Re: Morrison Supply 301 Indiana SE_{cc}
Request for Permanent C.O. – Acceptable
Engineer's Stamp dated: 08-08-13 (K-18/D021)
Certification dated: 4-30-14

**Re: Morrison Supply
Request for Permanent C.O. – Not acceptable
Engineer's Stamp dated: 08-08-13 (K-18/D021)
Certification dated: 12-12-13**

RE: **Morrison Supply – Warehouse, 301 Indiana SE**
Grading & Drainage Plan for Building Permit
Tract 6-A-1, Block 14, Fairgrounds Addition

File **K18-D021**
PE Stamp: 6/21/13

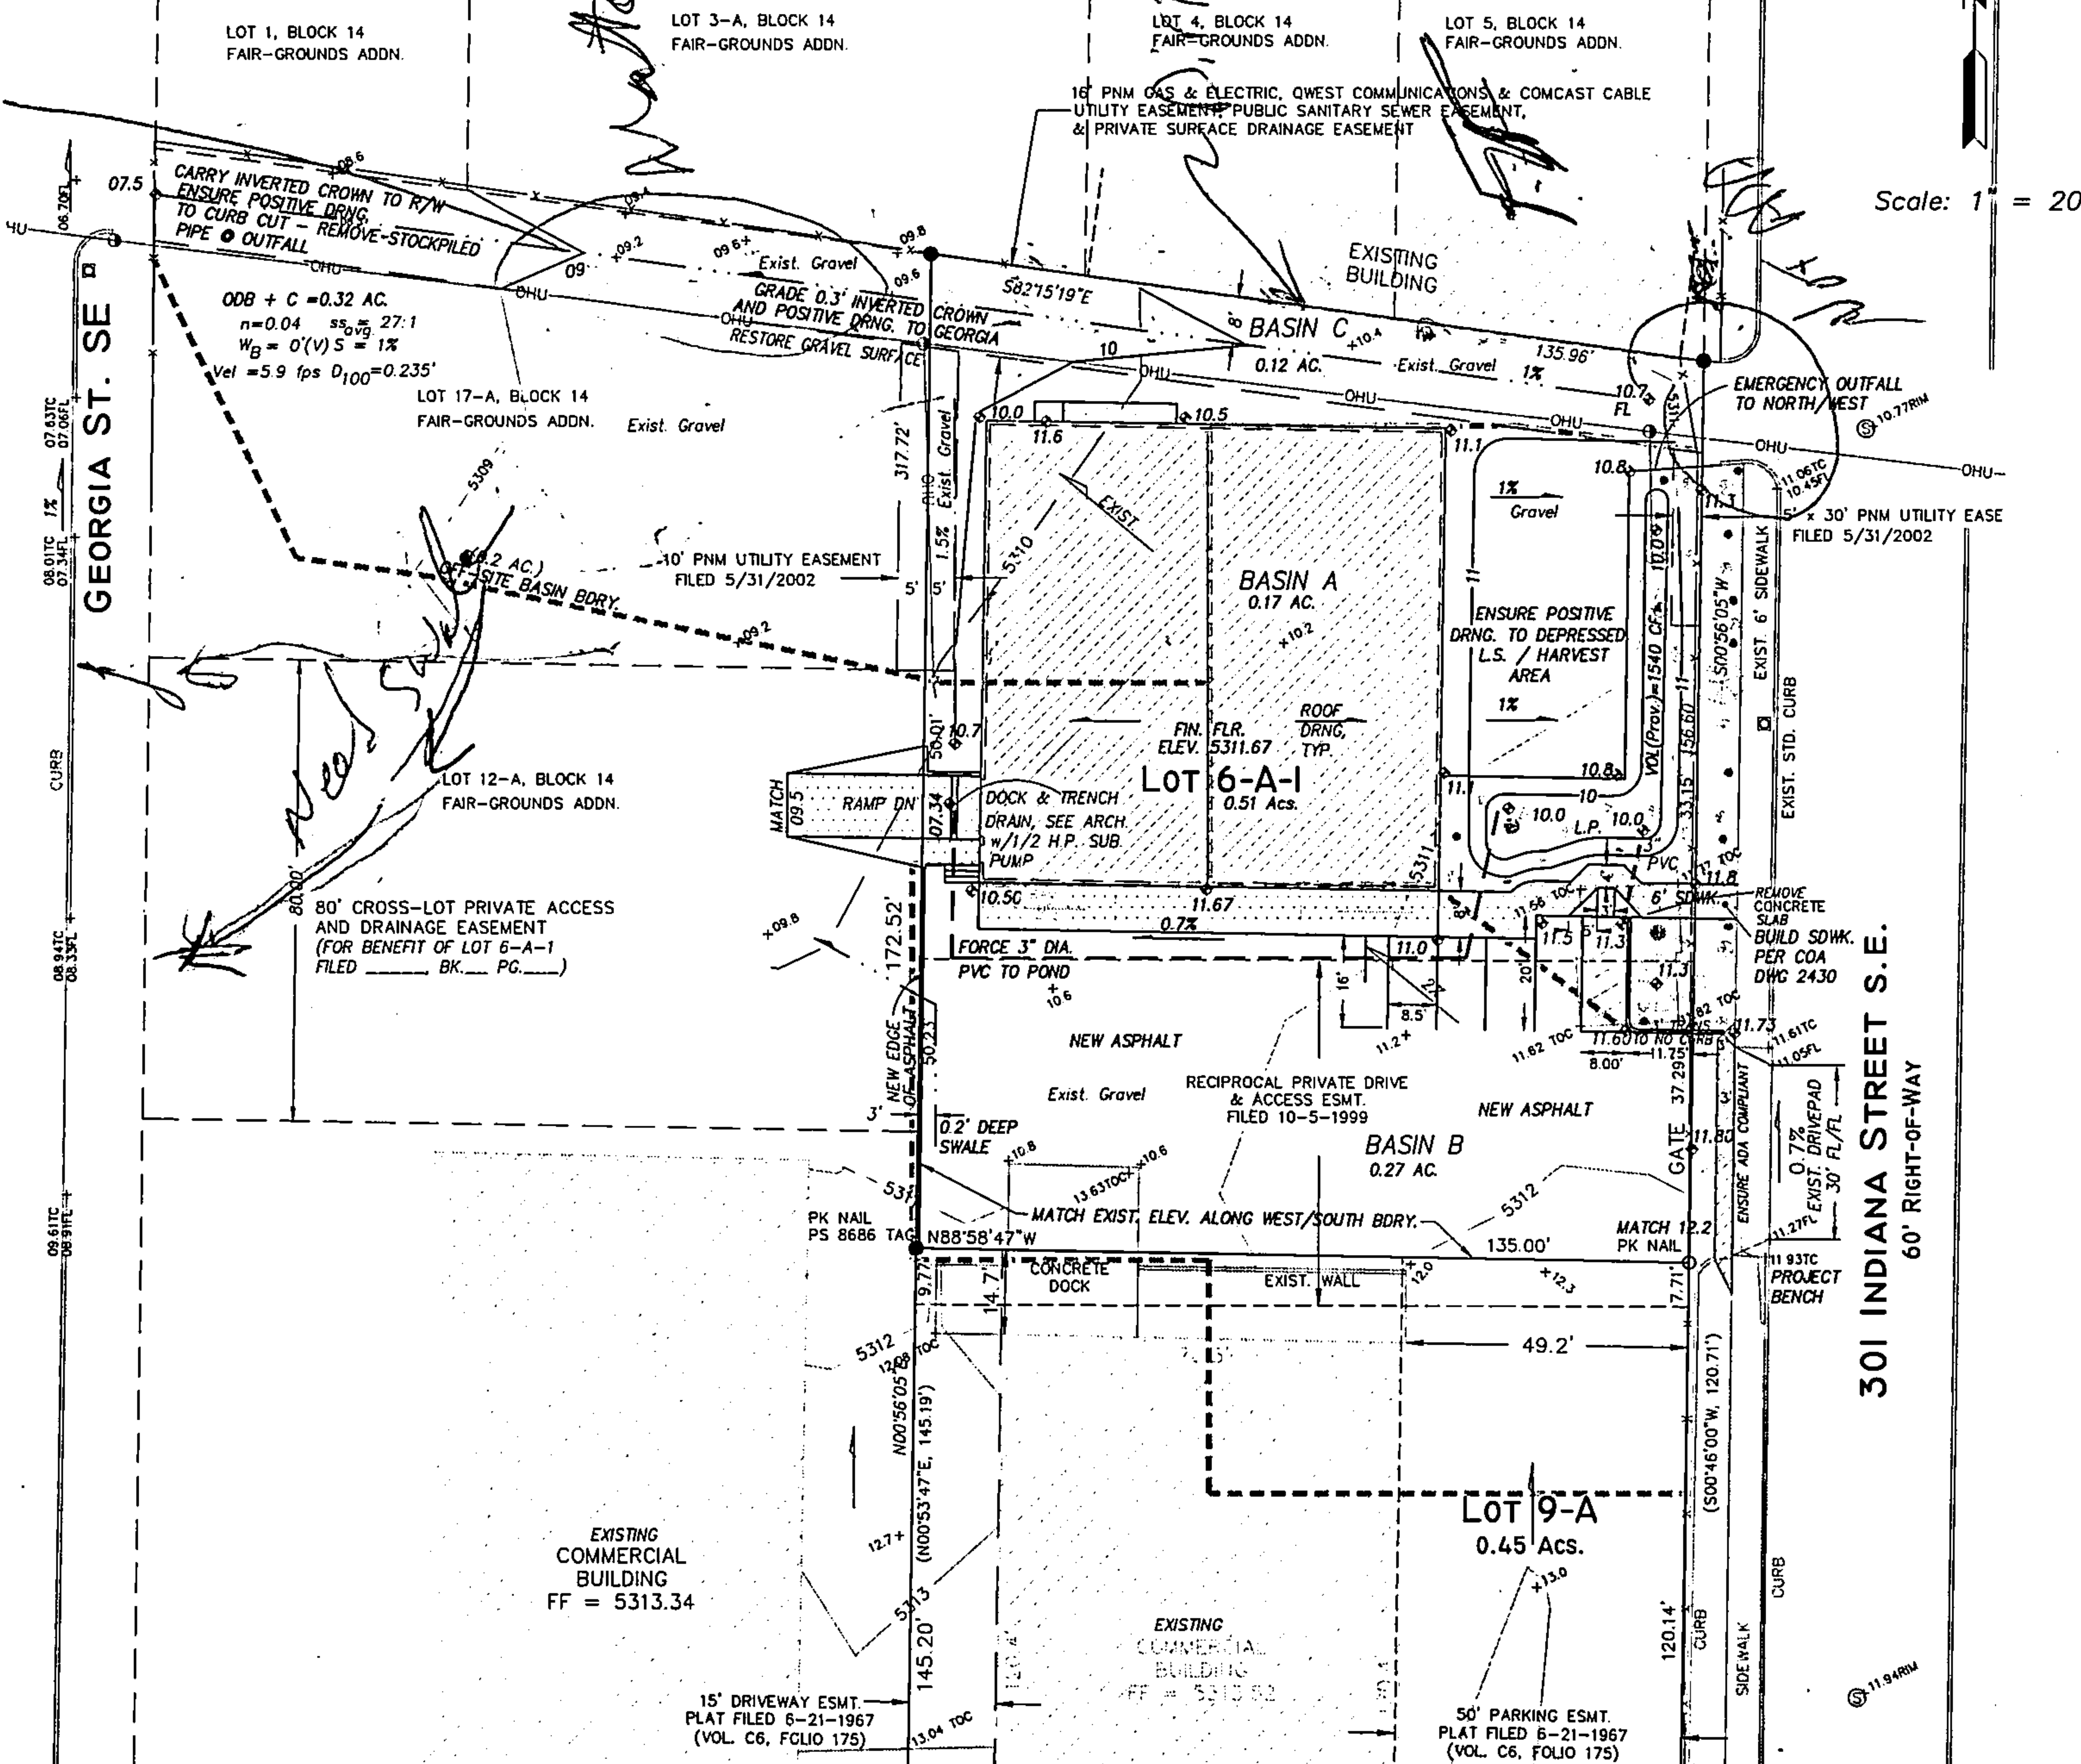
Based on the Certification received 12/12/2013, the site is not acceptable for release of Certificate of Occupancy by Hydrology. The exception for the alley not being graded is appreciated and duly noted. However, because the alley was not graded to ensure positive drainage, flows from the roof and the alley itself are draining toward a building and property to the north, adversely impacting this area.

There are also concerns with the flows to the west of the new building leaving the site over the public sidewalk on Georgia St., leaving debris on the sidewalk adversely affecting the public. These flows should be exiting either the alleyway driveway on Georgia St. or the entry/exit driveway to the south of the alleyway on Georgia St.

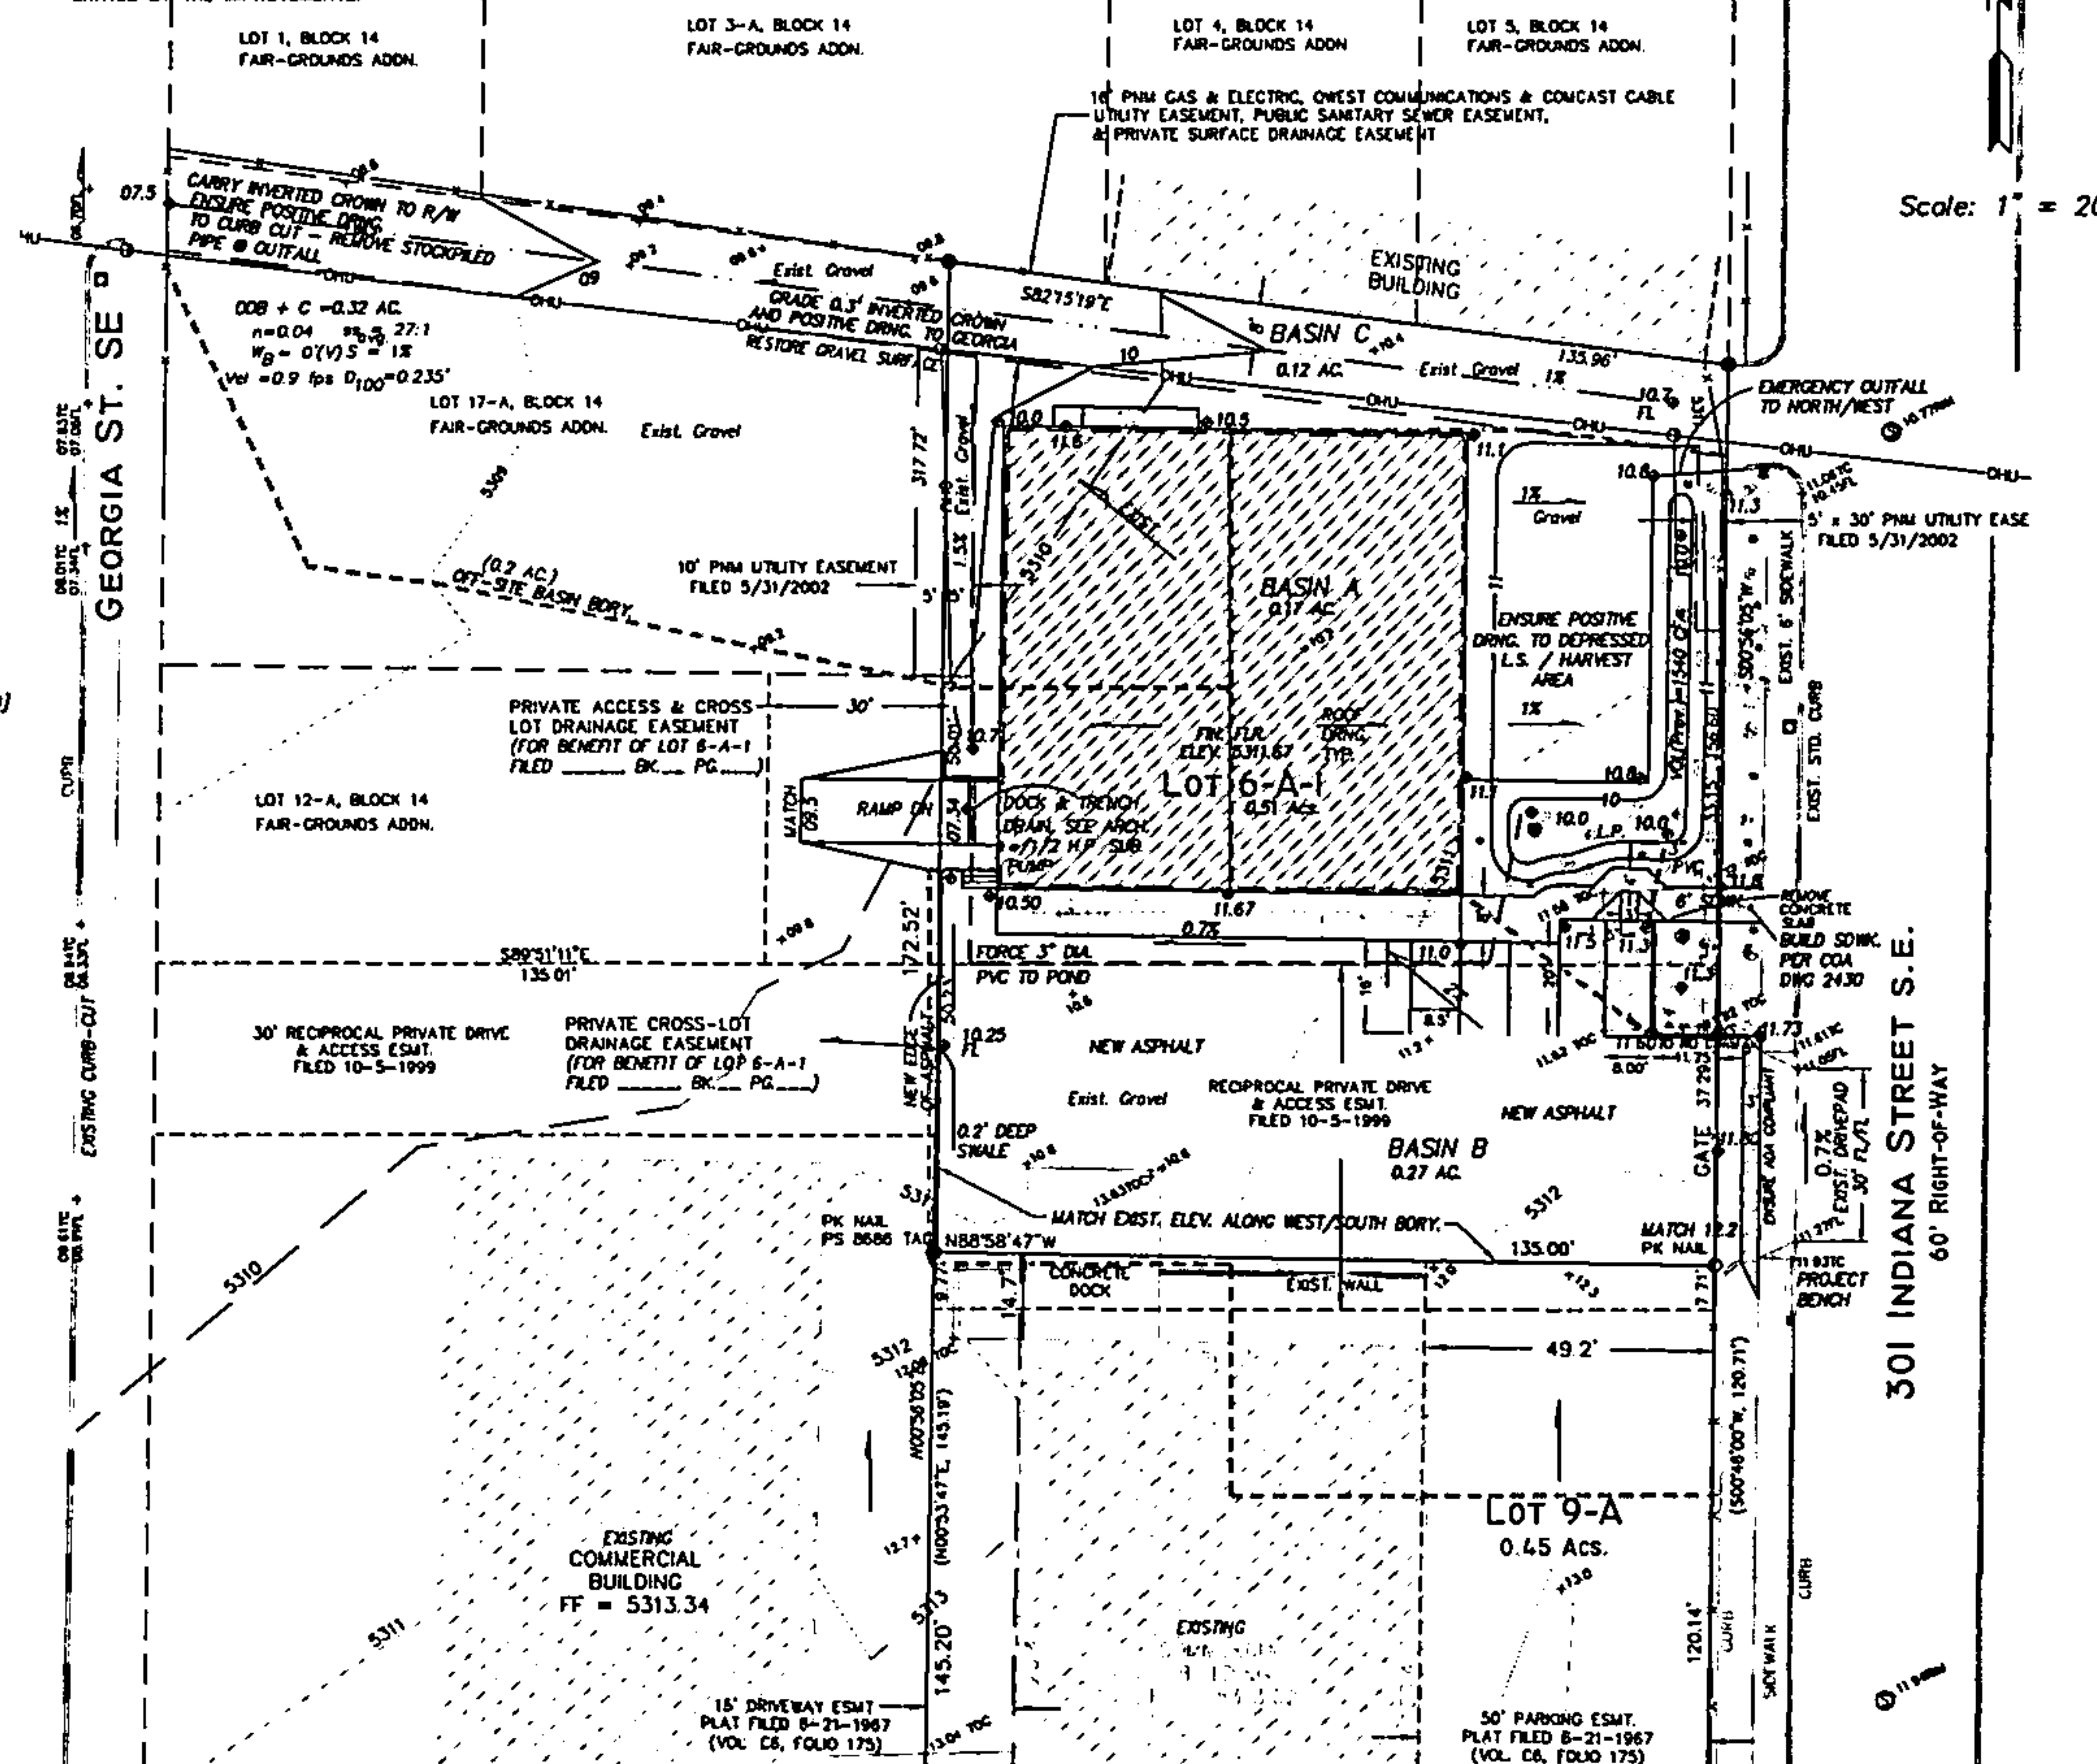
1. The drainage plan does not recognize off-site flows from the NE corner of Lot 9-A. Grades provided indicate roughly 0.10 acre of that lot discharging to this site.

2. This plan shows a loading bay / ramp, west of the building, which acts as a sump for runoff from the southern 25% of the site paving. Provide pump calculations to show that flows intercepted at this point are conveyed to the harvesting pond, as shown, and are not allowed to overflow to Tract 12A at elev. 9.50.

3. Is the 8" force main intended to run under the building pad? The Referenced Mech. Plan was not provided with this submittal. (7/31 revision to 4" line around building appears ok)

4. Provide sizing of the sump pump(s) to discharge to the eastern pond. (Your 7/31/13 proposal of a Zoeller 268 Pump appears undersized.) Provide calculations of runoff entering the sump in the design storm, and size pump(s) and pipe accordingly.

5. Provide documentation of the Construction Easement and Access Easement necessary to support the ramp construction and operation on Tract 12A.
6. Clarify the point and direction of overflow from the water harvesting pond, on the east edge of the site. Will flows exist through the old alley entrance, northeasterly to Indiana Street, or will they drain westerly in the vacated alley corridor?

7. Sub-basin boundaries would be helpful in quantifying proposed run-off.

8. This plan has a note to "ENSURE 0.3' INVERTED CROWN AND POSITIVE DRNG, TO GEORGIA" in the Private Surface Drainage Easement (Vacated Alley) along the north edge of Lot 17-A. Provide survey to verify this, or contours and additional spot elevations for grading of the drainage corridor. In my 7/30/13 field visit, I observed the old alley corridor to be heavily obstructed by material/equipment storage, potentially causing a mid-block diversion of runoff flows to private property on the north side of the easement. This plan and construction must confirm the outfall capacity to Georgia and/or Indiana St.
